Horsley Witten Group

March 9, 2007

**Re: Notice of Intent Review – Herring Brook Meadow, Scituate, Massachusetts
DEP File # SE-068-1988**

FEMA Flood
Herring Brook Meadow
Scituate, MA

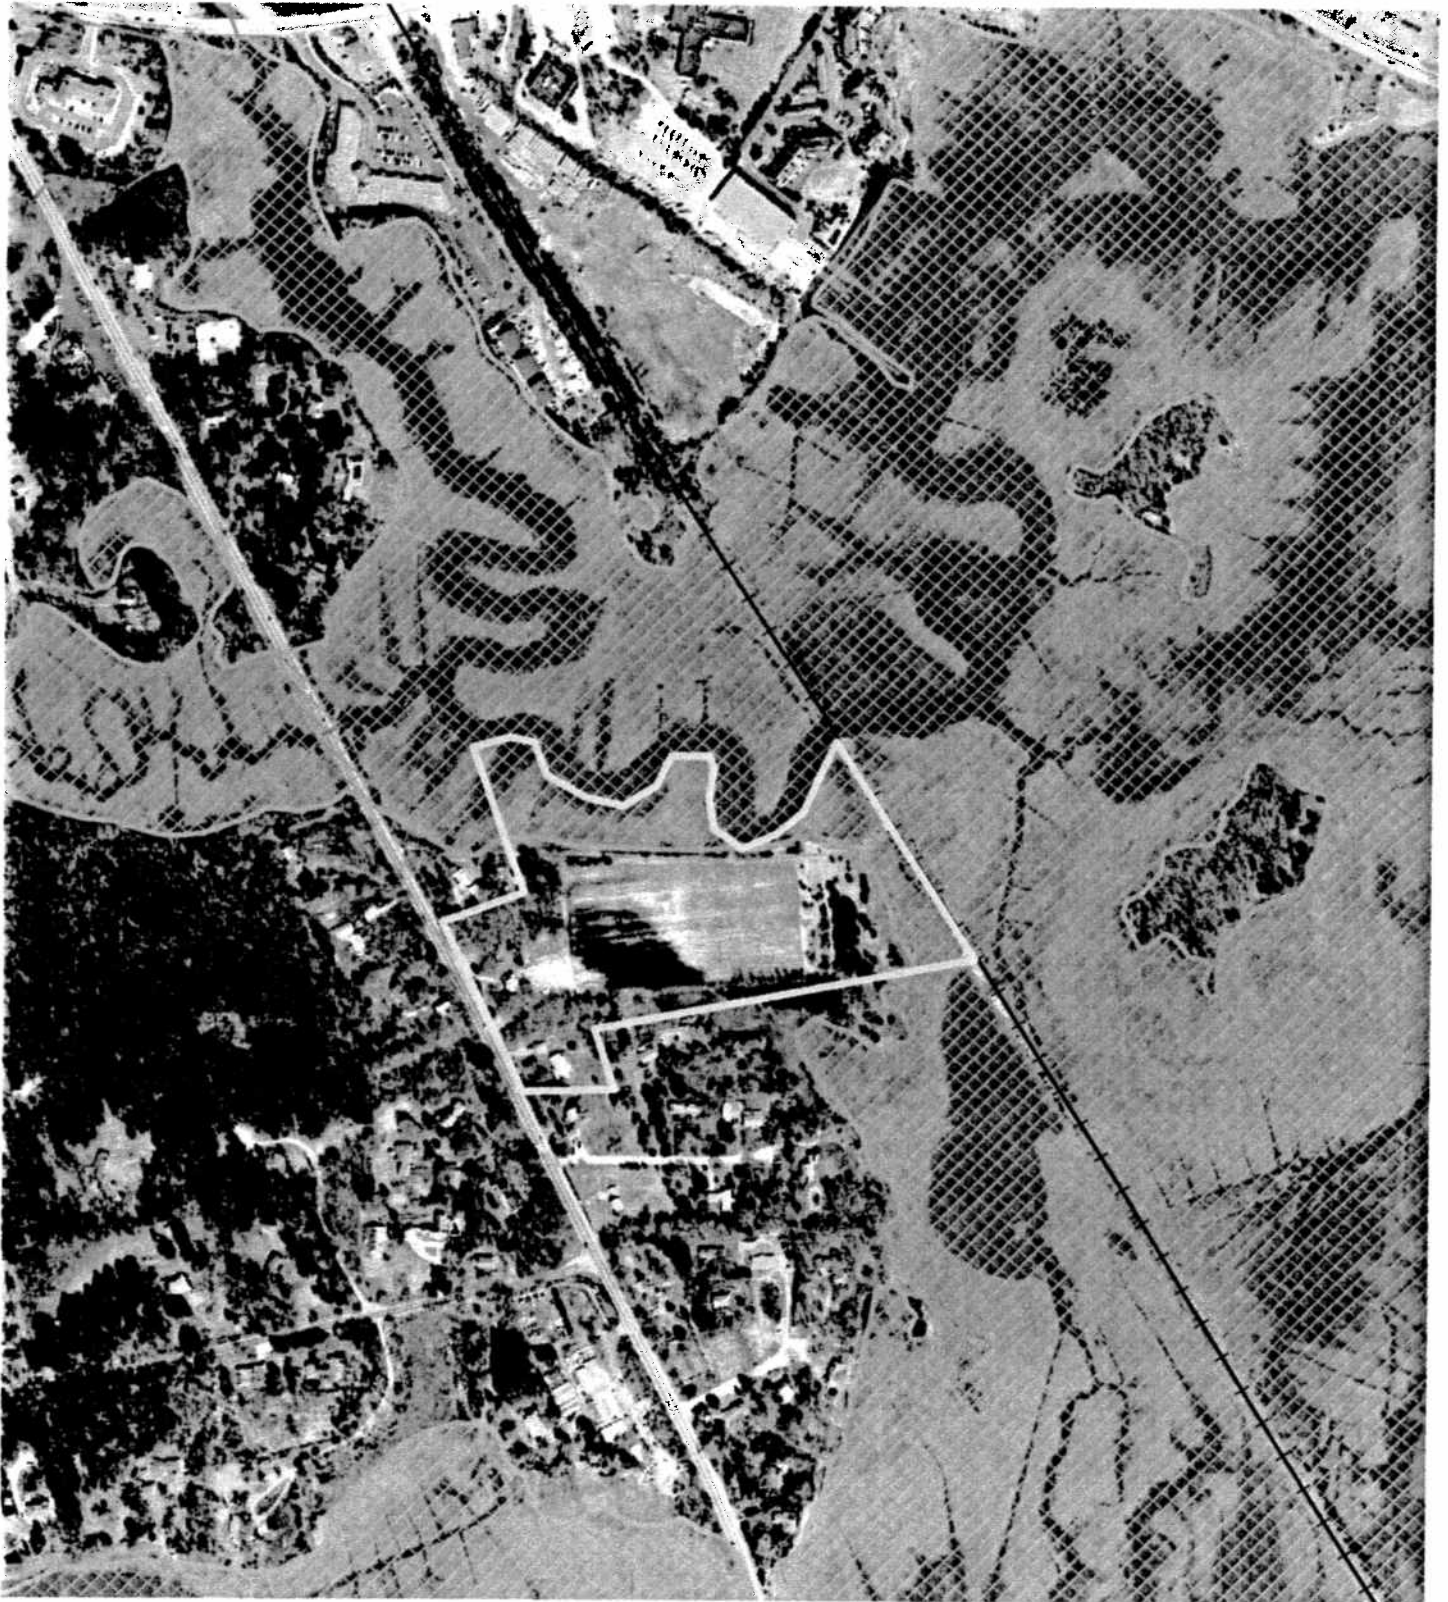
The property is located within the AE floodzone (LSCSF), as regulated by the Federal Emergency Management Agency (FEMA). The National Flood Insurance Program (NFIP) Flood Insurance Rate Map shows the site's AE flood Zone at elevation 11 (Figure 3). Land Subject to Coastal Storm Flowage is defined at 310 CMR 10.04 as *land subject to any inundation caused by coastal storms up to and including that caused by the 100-year storm, surge of record or storm of record, which ever is greater.*

Although there are no performance standards within the WPA Regulations for LSCSF, it is generally accepted that LSCSF is significant to the interests of storm damage prevention and flood control. The applicant proposes to place substantial amounts of fill within LSCSF (up to seven vertical feet of fill material). This amount of fill has the potential for altering storm surge flow patterns, increasing the potential for off-site flooding, and arguably altering existing drainage patterns at this site. Section 10.38 of the Town of Scituate Wetlands Rules and Regulations discusses the importance of velocity zones (VE-Zones) and AE-Zones for storm damage prevention and flood control. The general performance standard of this section states: "*any activity shall not have an adverse effect by increasing the elevation or velocity of flood waters or by increasing flows due to a change in drainage of flowage characteristics on the subject site, adjacent properties...*" The Commission may want to request that the applicant provide the Commission with data demonstrating how this project will meet this performance standard.

- Request that the applicant submit additional information (calculations, studies, plans) demonstrating that the proposed alterations within LSCSF will not have an adverse affect by increasing the elevation or velocity of flood waters, increasing or changing drainage flow characteristics, or increasing flooding on adjacent properties.

**Existing Constraints
Herring Brook Meadow
Scituate, MA**

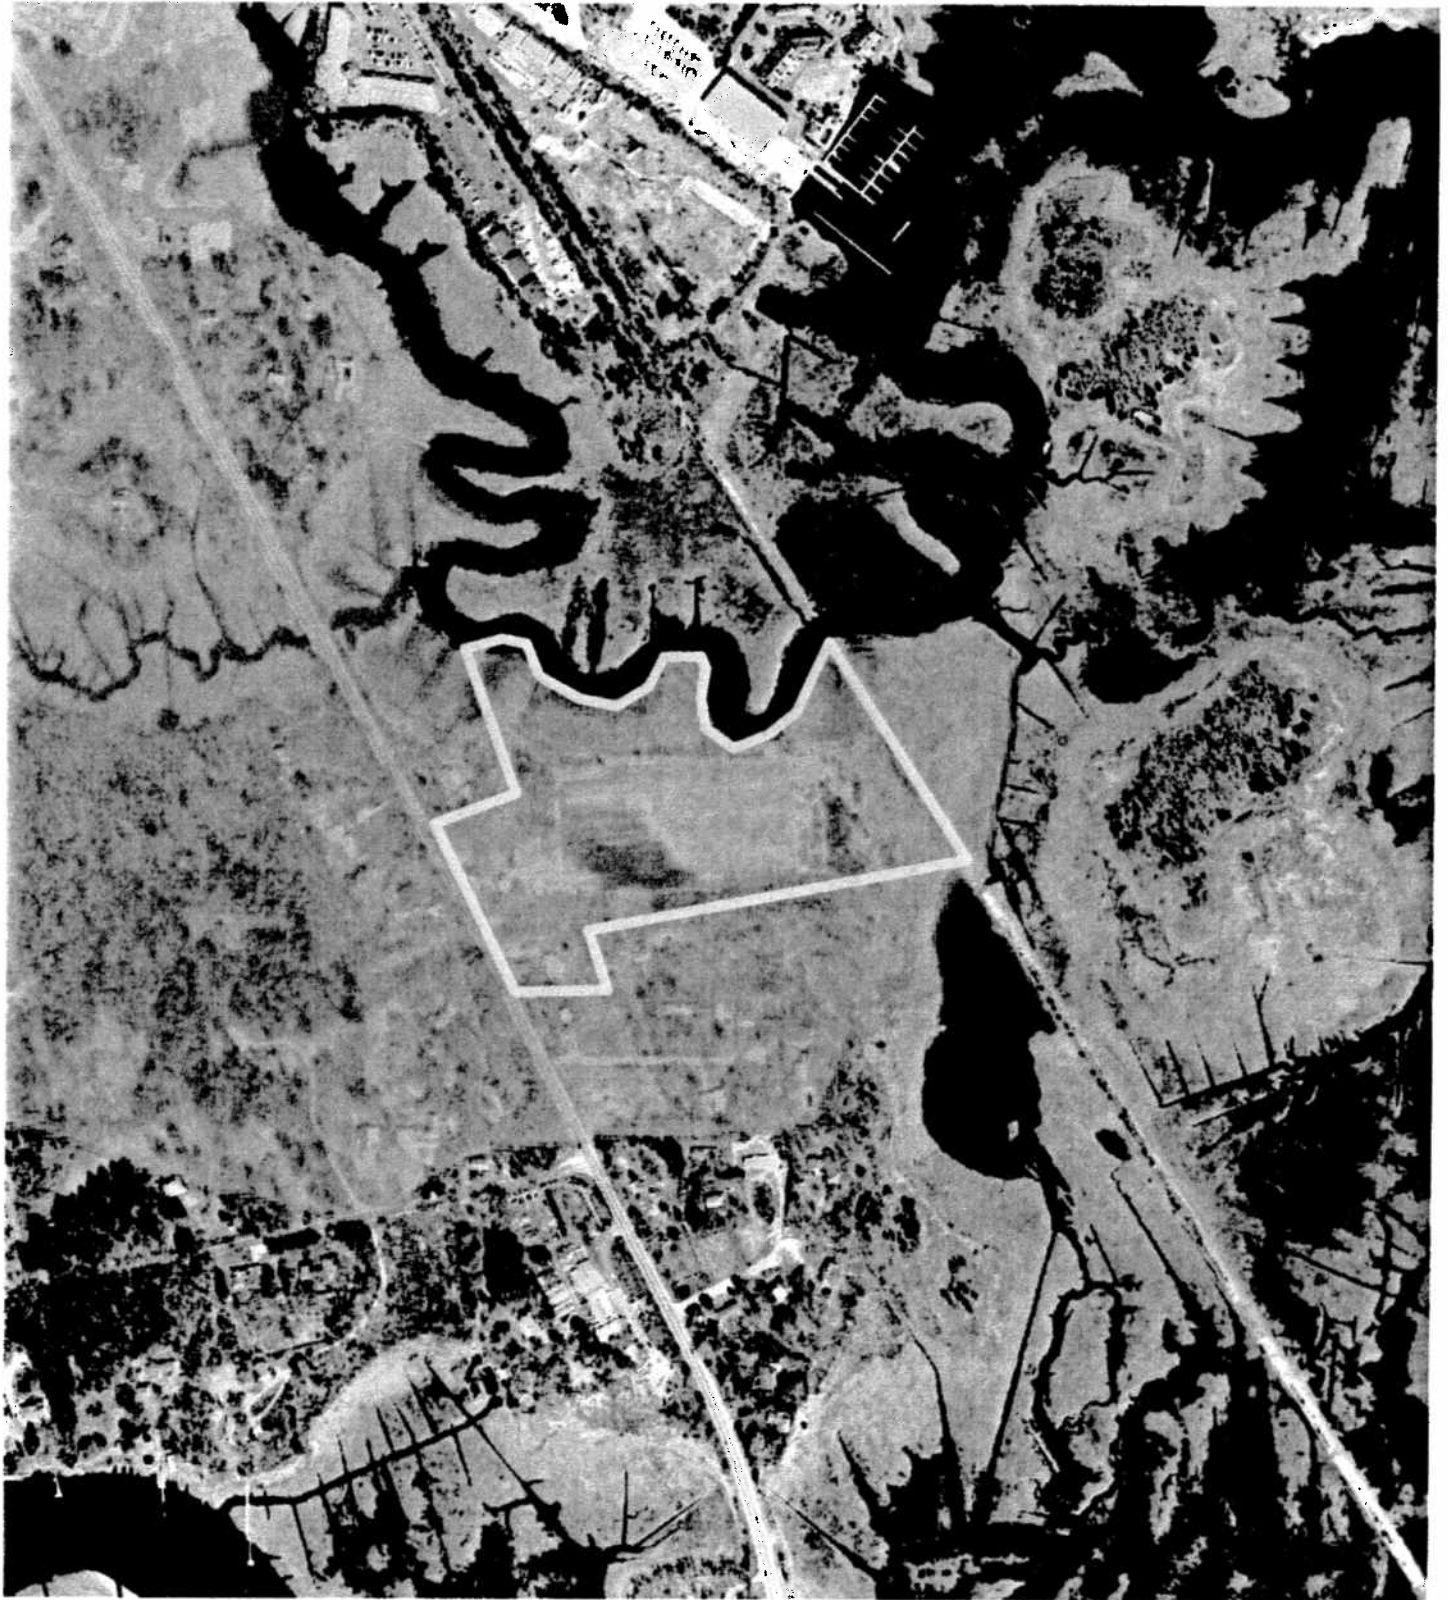
According to the most recent version of the Natural Heritage Atlas (October 1, 2006), a portion of this site occurs within both *Estimated Habitat of Rare Wildlife and Certified Vernal Pools* and *Priority Habitat of Rare Species* (Figure 4). Although it appears that no work will occur within these designated habitat areas, it would be useful to have the limits of these areas depicted on all sheets of the plan set. The narrow strip of land to be transferred to the Town as proposed Public Open Space may occur within the limits of these designated habitat areas, which in turn may have long term land management implications for the Town.

- Request that the applicant consult with the Massachusetts Natural Heritage and Endangered Species Program (NHESP) to ensure that the proposed project will not have any adverse impact to the habitat of one or more State-listed rare species that may require additional review under the Massachusetts *Endangered Species Act* (M.G.L. Ch. 131A) or MESA.
